Subject: Transportation Consulting Services
Proposed The Sanctuary at Ashland Mills (40B)
10-60 Main Street, Ashland, MA

MDM Transportation Consultants, Inc. (MDM) is pleased to provide you with the following supplemental transportation review comments for the above-referenced project. These comments have been prepared based on review of Proponent's response memorandum prepared by VAI dated February 27, 2025, project coordination meeting with the Town of Ashland department heads on Wednesday, March 12, 2025 via Zoom, and a review of updated Site plans prepared by Bohler Engineering dated March 12, 2025 as identified below. To facilitate response by Proponent, review items requiring response are noted in ***Bold Italic***.

SU-40

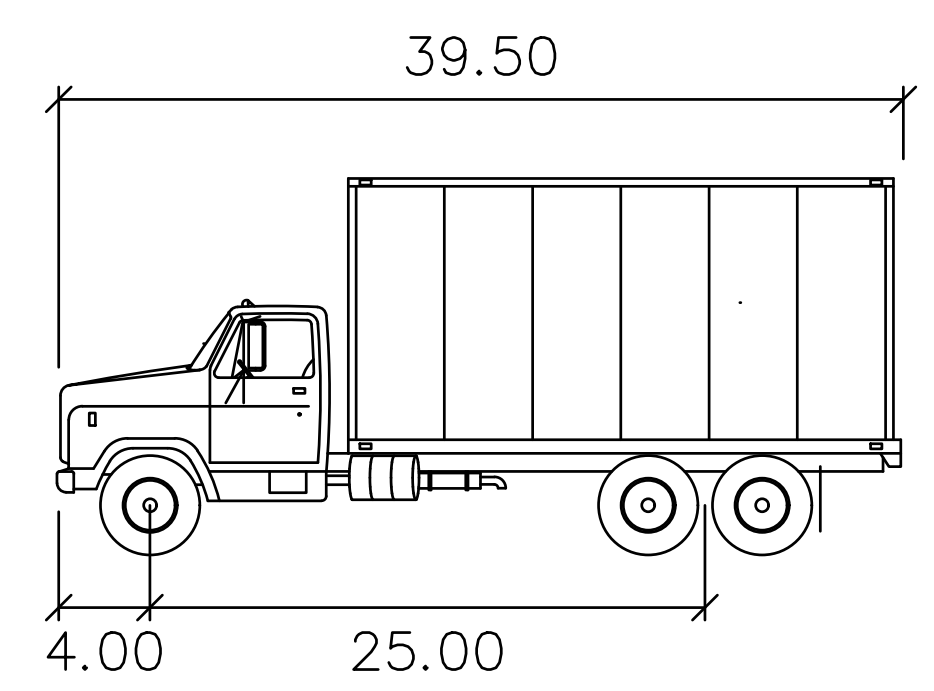
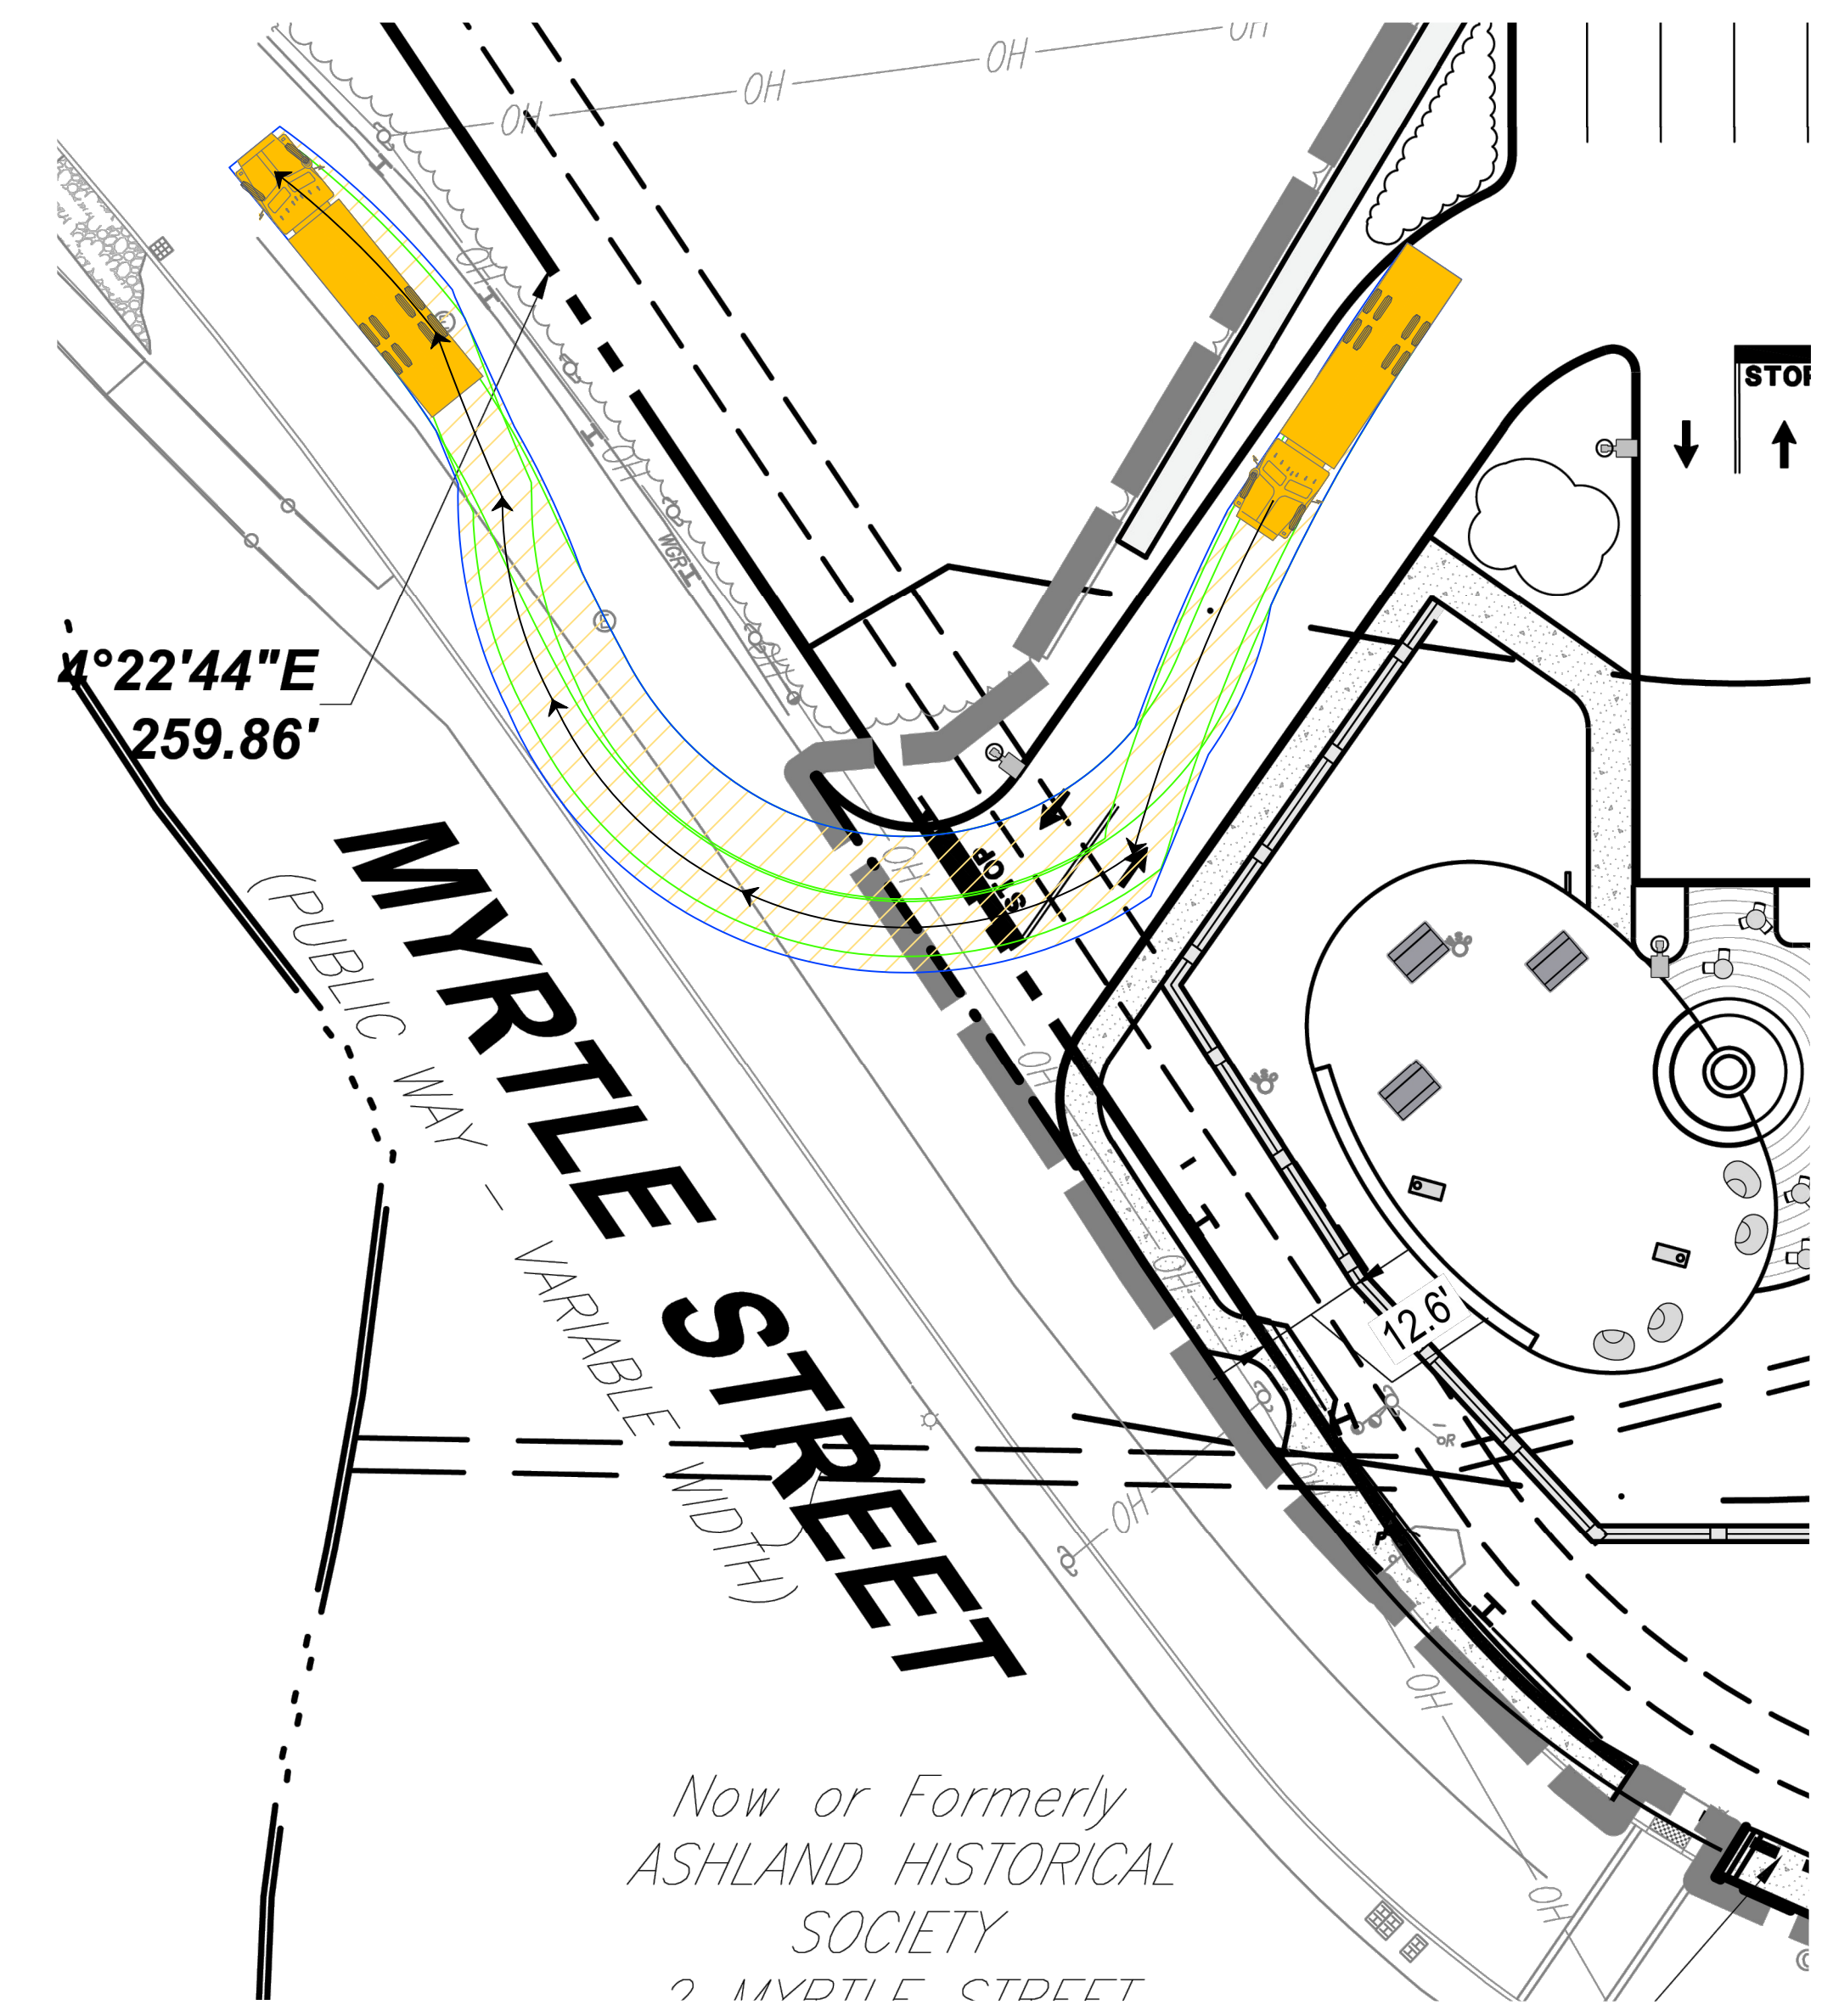
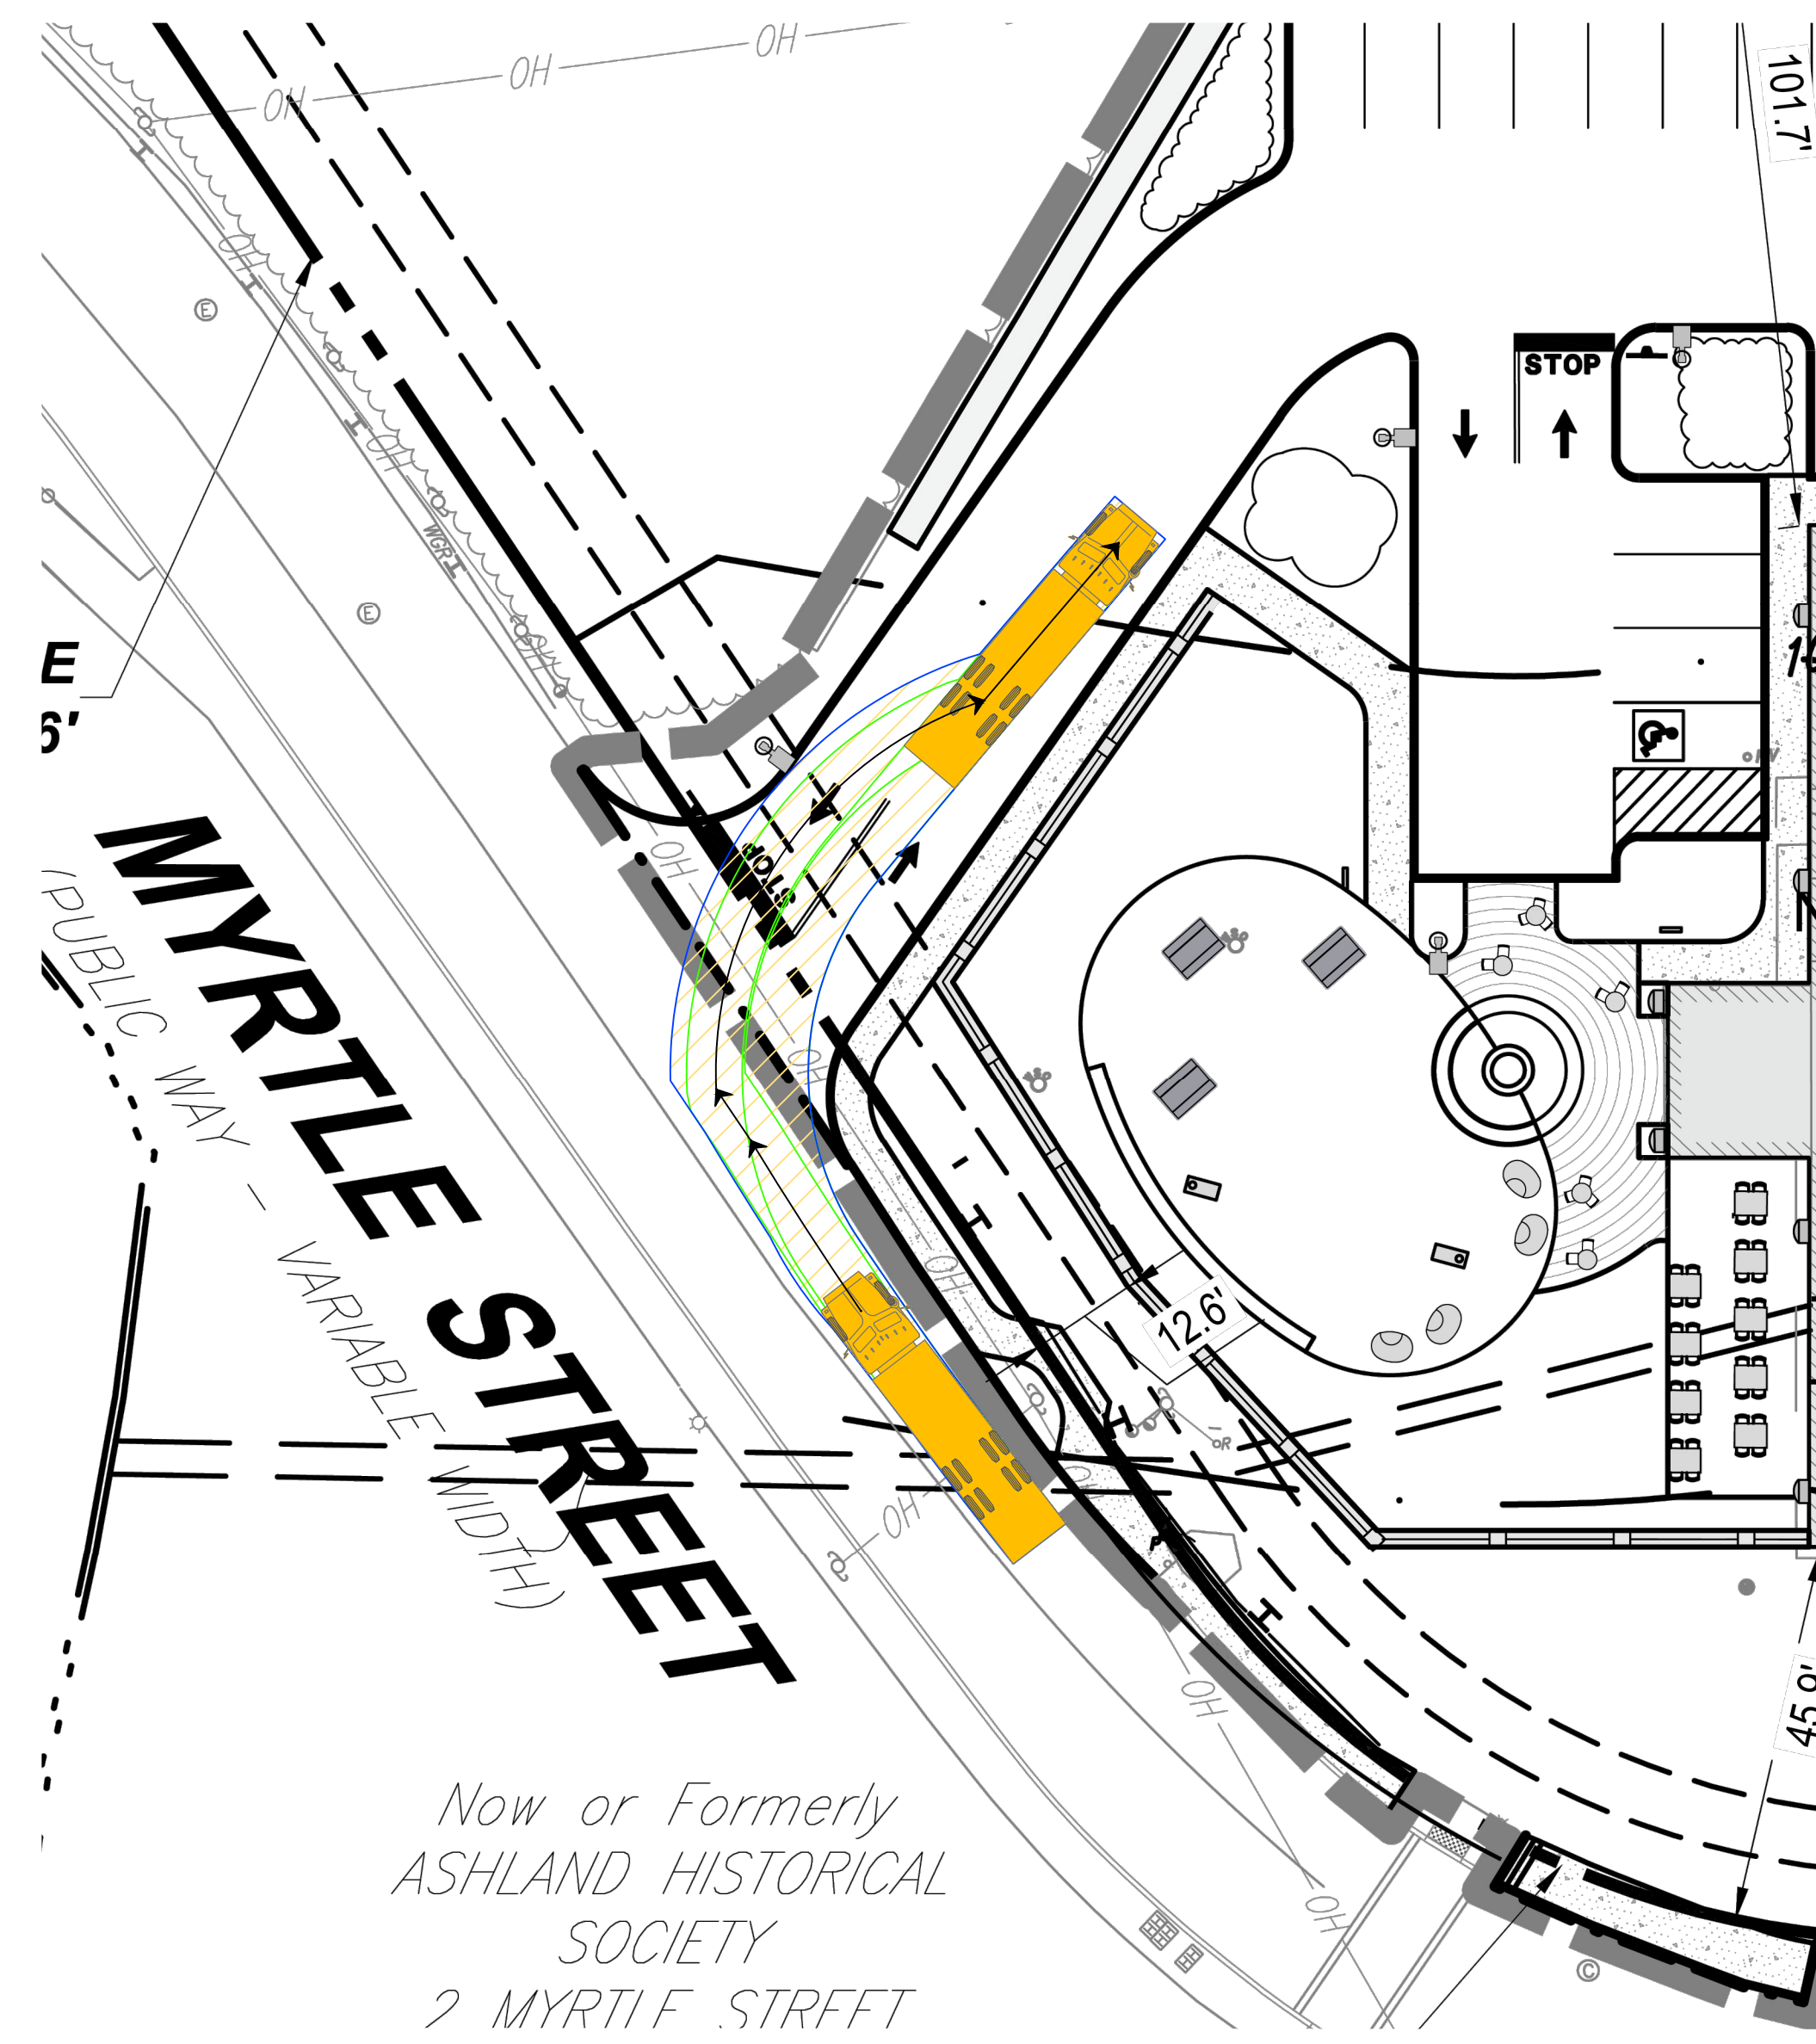
Supplemental Comment: Driveway designs must be modified at the Myrtle Street and Main Street south driveway to eliminate opposing lane encroachments including (in the case of Myrtle Street) encroachment into Myrtle Street southbound lane for right-turn exiting movements.

Supplemental Comment: MDM does not concur that the driveway as proposed meets applicable design requirements for service, delivery, move-in or fire apparatus maneuvering whether these movements occur peak or non-peak. The skewed driveway alignment requires for each of these vehicle types a wide sweep into the opposing travel lane of Myrtle Street or (for entering movements) a wide sweep into the exiting lane of the driveway. This presents a significant safety concern that must be addressed by modifying the driveway alignment and/or adjusting curb radii so that movements do not impact opposing travel. See attached swept path exhibits which illustrate swept paths for various vehicle types based on currently proposed driveway design.
